SITE PROBLEM REPORT

CUSTOMER MET ED	CONTRACT NO. 620-0005	SPR NO. 289	REV. NO. 0
VENDOR BMO	P.O. NO.	TASK NO. 21	GROUP NO. 01
SITE ENGINEER S. P. MAINGI	REQ'D. RESOL. DATE	REQ'D. COMP. DATE

TITLE ICS RESPONSE DURING TURBINE TRIP

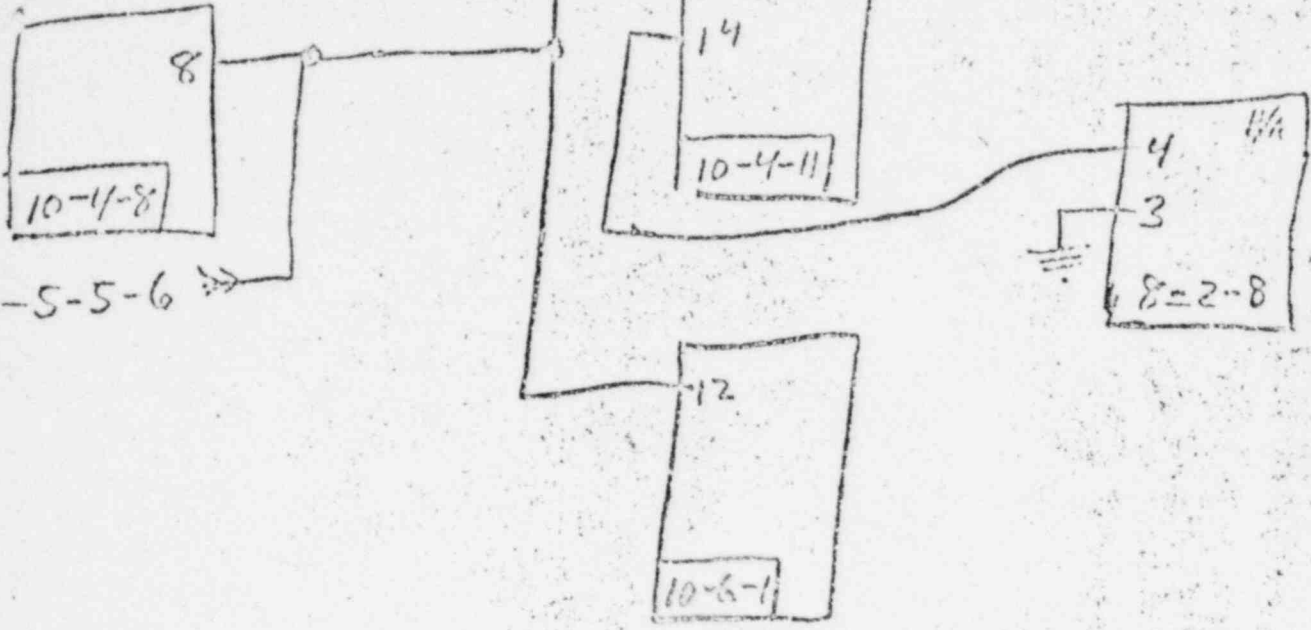
1. Turbine throttle pressure immediately jumped to 1060 psig.
2. BTU limits actuated to reduce FW flow demand.
3. FW valve ΔP dropped to ZERO.
4. FW error sent cross limit to the reactor.
5. The reactor ϕ error sent cross limit to the feedwater.
6. The feedwater flow dropped from 65% to 25% and then recovered.
7. The reactor average temperature went to 590°F (11°F high).
8. At 1 1/2 minutes into the transient the T_{AVE} came back to setpoint but the RC pressure was dropping close to the LO Pressure Reactor trip point. The operator took control of both FW demand stations and dropped feedwater flow to save RC pressure.

1. Add a feed forward from turbine header pressure to feed pump speed control to raise speed demand when the header pressure jumps up on turbine trip. Present 35 PSI ΔP across FW valve train is lost when the header jumps up by 170 PSI.
2. Review BTU Limit operation during this transient to see if its action was correct. In other words, do we want to immediately step FW flow down on a turbine trip.

ENCLOSURE-1

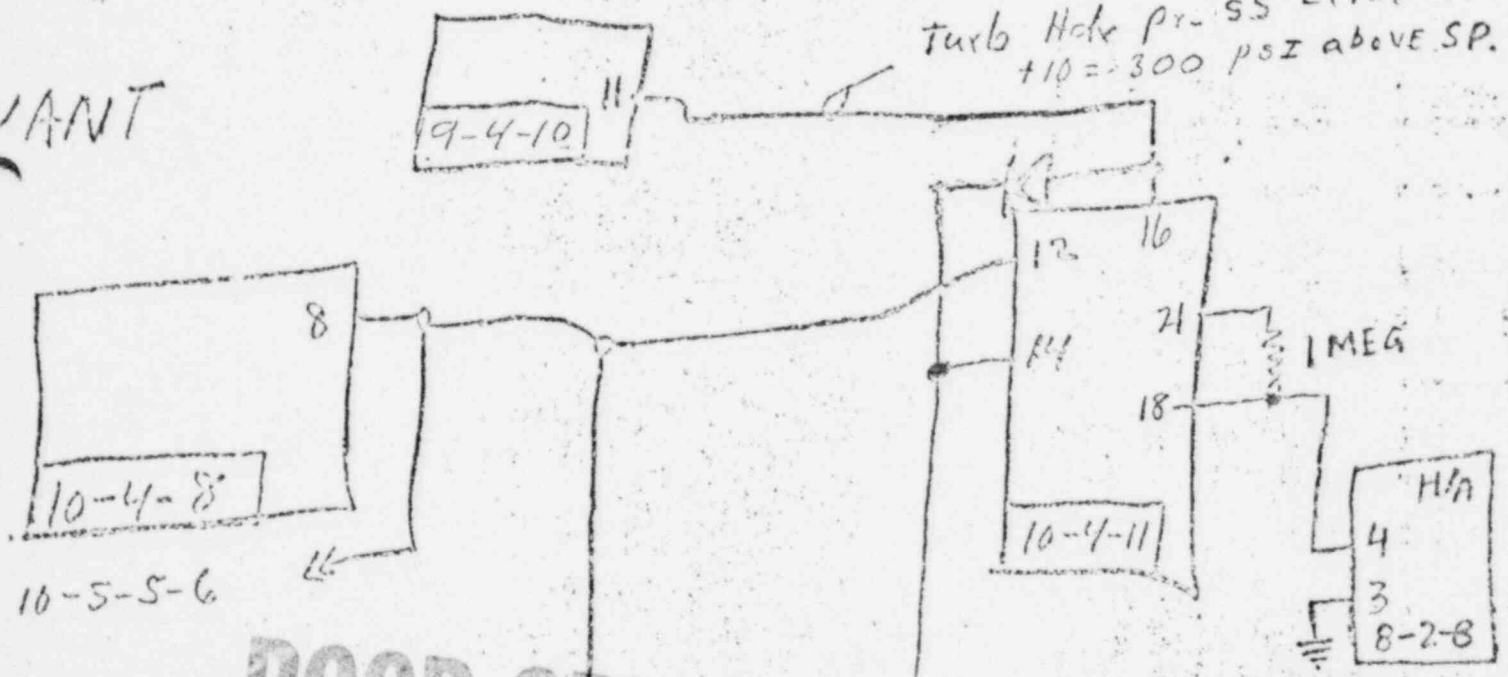
Turb Hole pr-SS Error
+10 = 300 psz above SP.

recommended for installation & test

psI psI
1050 - 885 = 165 = $\Delta 27.5\%$ to change FPS
20% E. Gain = 0.727

Per our discussion today we approve the item 3 under "Further Action Recommended Site Personnel" of the subject SPR. The modification suggested is illustrated on an attachment to the SPR which understands that this modification is the addition of the throttle pressure error to a summer which provides the control action for increasing or decreasing the main feedwater pump turbine speed.

A. This change should not be made at power.
